ADDENDUM NO. 01

Baggage Screening Improvements – Phase 2A
[Loading Dock Reconfiguration, Sheriff’s Checkpoint Removal, Jetway Installation
(Gate 30, 46, 47), IAB Airside Trash Remodel, North Checkpoint Relocation]

PROJECT NO. A044-09002

DATE OF ADDENDUM: June 9, 2011

E105A

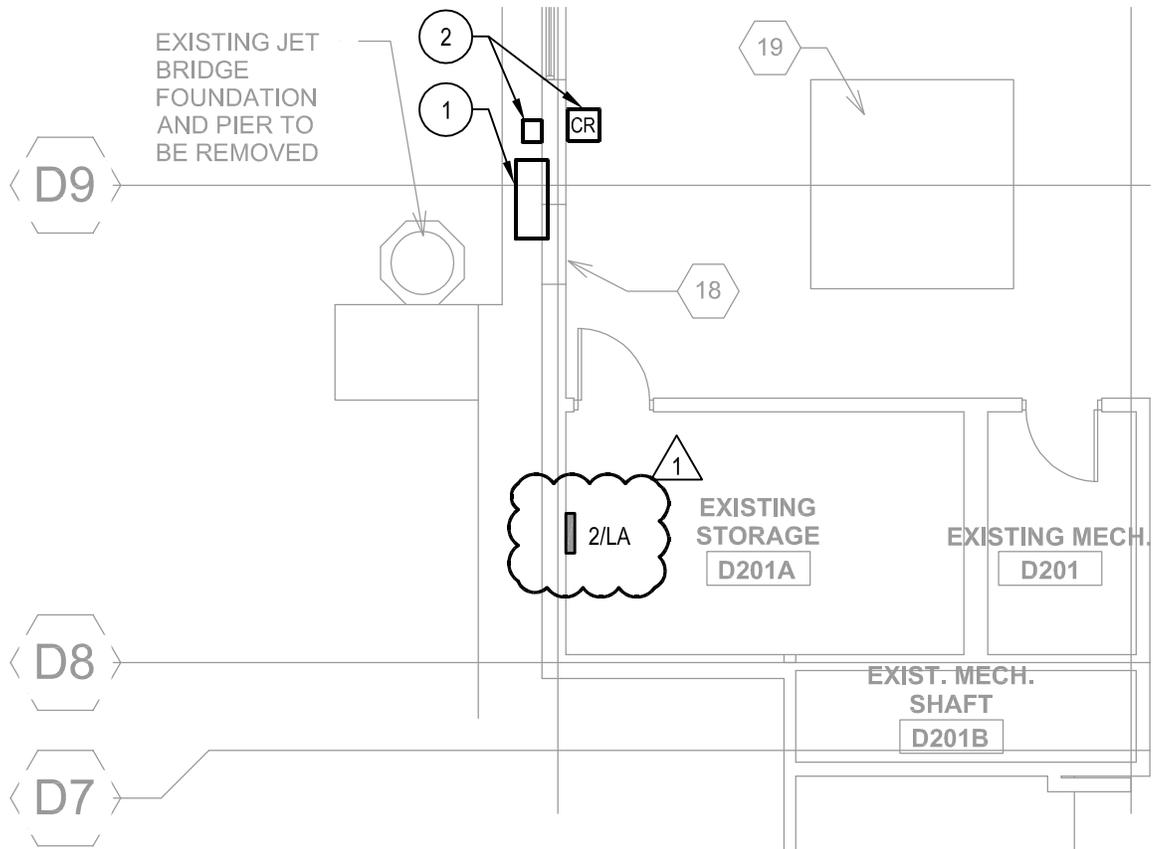
- Added routing and cable information for new podium as shown in attached sheet.
- Added location of panel 2/LA as shown in attached sheet.
- Added Notes 11, 12, and 13 as shown on attached sheet.
- Revised wording of Note 5 from "Provide (2) 1 ½" conduits stubbed up through floor" to "Provide (2) 1 ½" conduits from new junction boxes stubbed up through floor"

E600A

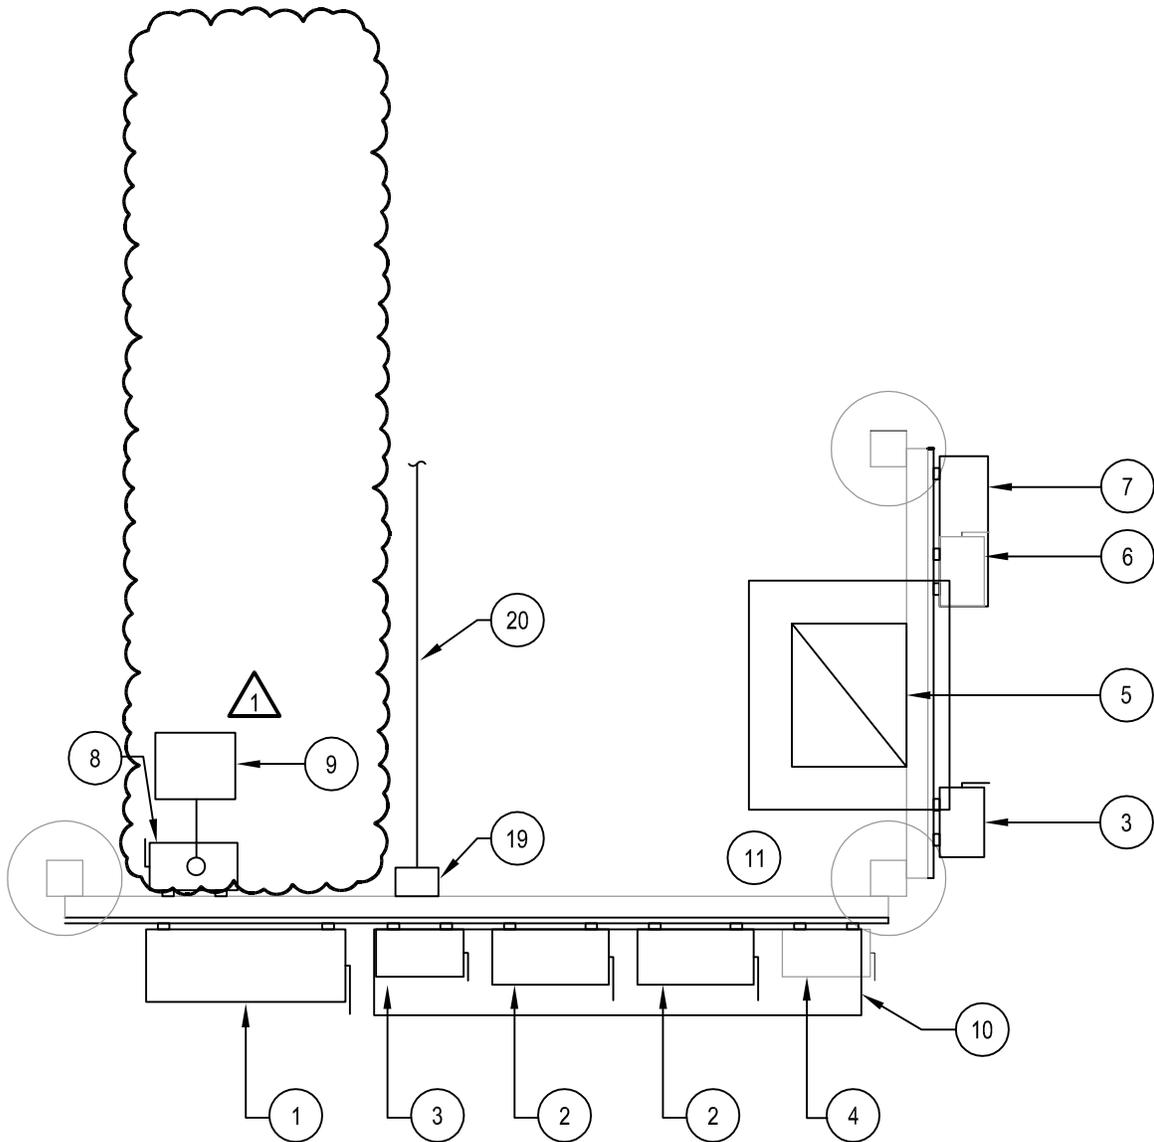
- Change conduit size for feeder from breaker in panel NES/DPA to disconnect switch and from disconnect switch to transformer in detail 2 from ¾" to 2". (see attached drawing)

- 13) Underground feeder to guard house has two designations (E100A , E600A). What size conduit and conductors from Panel NES/DPA? **Response:** **Refer to corrected size in addendum.**

E701A

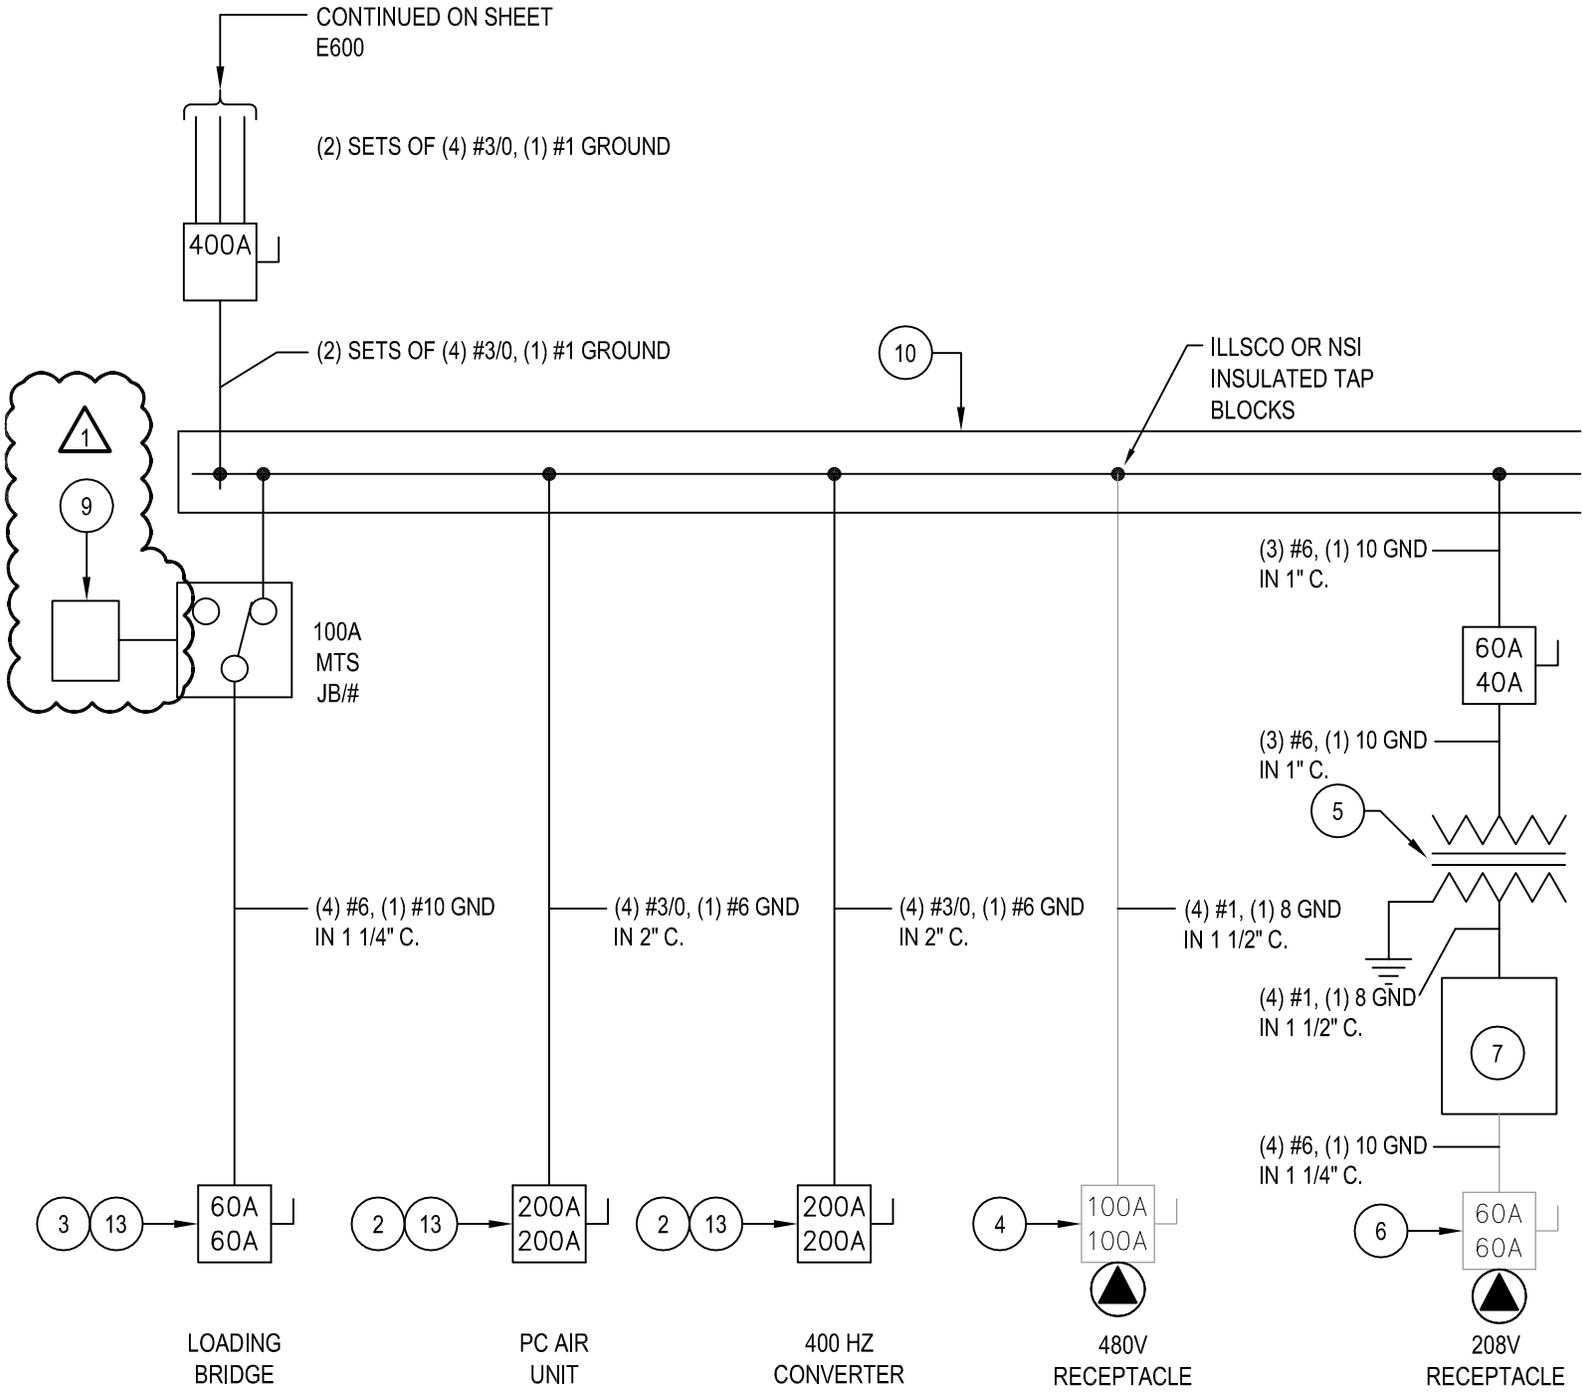
- In Detail 2, add junction box and reference to Key Note 9 as shown on attached sketch.
- In Detail 4, add junction box and reference to Key Note 9 as shown on attached sketch.
- Change Note 1 to read "Connect to new 400Amp/3P 600V nonfused disconnect switch."
- Change Note 17 to read "Not used."

- 7) Drwg E701A jet bridge detail Note #1: Indicates 400A disconnect switch is existing and is fused. Plan drawings and notes indicate 400A jet bridge disconnects are new and symbol indicates un-fused. Please clarify whether jet bridge 400A disconnect switches are existing or new, fused or un-fused. **Response: These disconnects switches are new and unfused. This direction is included in the addendum.**

- 8) Drwg E701A jet bridge detail Note #9: Why would the 12 x 12 x 4 j-box indicated include llSCO distribution blocks? Should this part of note 9 be with note 10? Please clarify. **Note 9 refers to a junction box for future connection to an emergency source. This has been added and included in the addendum.**
